Subject ▶ Replacement of Hex. Socket Head Bolts

For Models ▶ 1050D, 1100, 1805B, 1806B, 1911B, 1923B

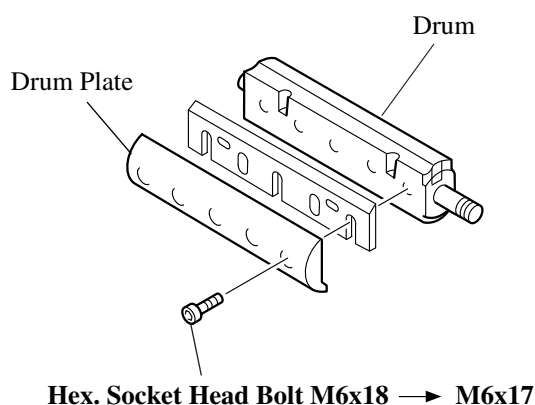
To secure Drum Plate more firmly, Hex. Socket Head Bolt M6x18's have been replaced by Hex. Socket Head Bolt M6x17's.

For standardization, Hex. Socket Head Bolt M6x18's have been replaced by Hex. Socket Head Bolt M6x17's.

Item No.	Current part		Q'ty	I/C	New part		Q'ty	Note
1806B: 030	Hex. Socket Head Bolt M6x18 265322-7		10	←	Hex. Socket Head Bolt M6x17 265484-1		10	
1050D: 036	Hex. Socket Head Bolt M6x18 265322-7		4	←	Hex. Socket Head Bolt M6x17 265484-1		4	
1100: 049 1923B: 913	Hex. Socket Head Bolt M6x18 265322-7		6	←	Hex. Socket Head Bolt M6x17 265484-1		6	
1911B: 054 1805B: 047	Hex. Socket Head Bolt M6x18 265322-7		8	←	Hex. Socket Head Bolt M6x17 265484-1		8
